**Project #22-052
Quick Quack Car Wash
Located at 1960 South 1000 South**

<i>Project Name:</i>	Quick Quack Car Wash
<i>Proponent/Owner:</i>	Jeremy Weber / Lower Willow LLC
<i>Project Address:</i>	1960 South 1000 West
<i>Request:</i>	Design Review Permit
<i>Current Zoning:</i>	Commercial (COM) (Gateway Overlay Zone)
<i>Date of Hearing:</i>	September 8, 2022
<i>Type of Action:</i>	Quasi-Judicial
<i>Submitted By:</i>	Russ Holley, Senior Planner

Staff recommends that the Planning Commission **approve** a Design Review Permit for Project #22-052 Quick Quack Car Wash for a 4,090 SF commercial building located at 1960 South 1000 West: TIN #03-207-0001.

Figure 2 shows the proposed site plan

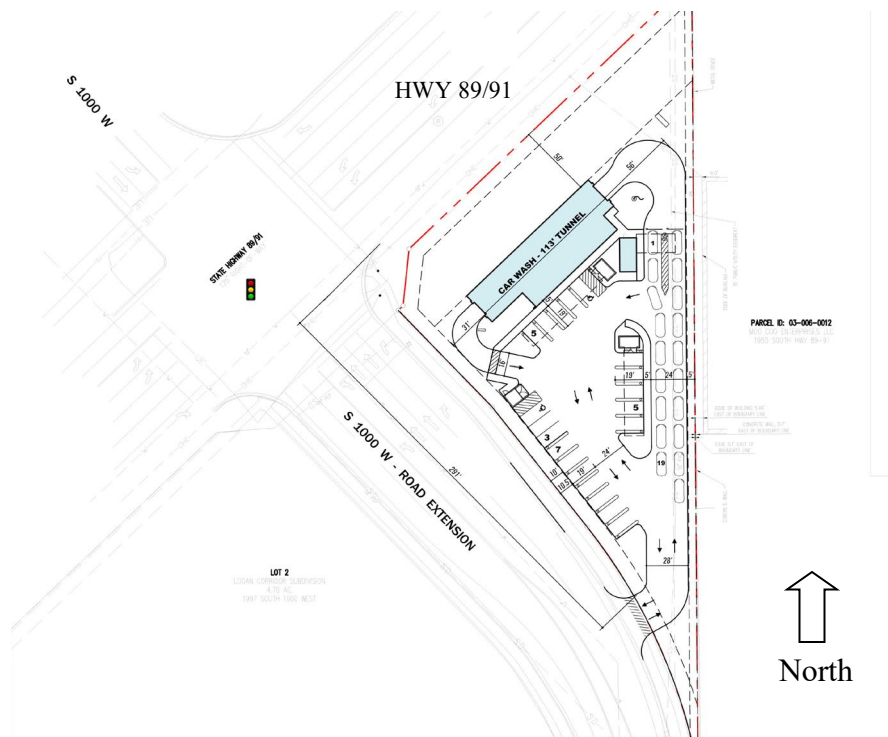
The LDC 17.10.030 requires safe and convenient pedestrian circulation that results in sidewalks connecting streets to buildings. The site layout places the new car wash along the HWY 89 corridor. A crosswalk and sidewalk are installed along 1000 West street. The proposed site plan shows sidewalks to the south of the building, but no connections are made to 1000 West. As conditioned with sidewalk connections, the proposed project meets the requirements in the LDC.

1. All standard conditions of approval will be recorded with the Design Review and are available in the Community Development Department.
2. The South Gateway Overlay Zone 50-foot setback adjacent to HWY 89/91 shall not contain buildings, parking lots and any other elements as per LDC 17.21.060. Landscaping is required inside the 50-foot setback area.

3. A minimum of six (6) car stacking stalls shall be located in the drive-thru lane.
4. A sidewalk connection shall be made from 1000 West to the building and parking area.
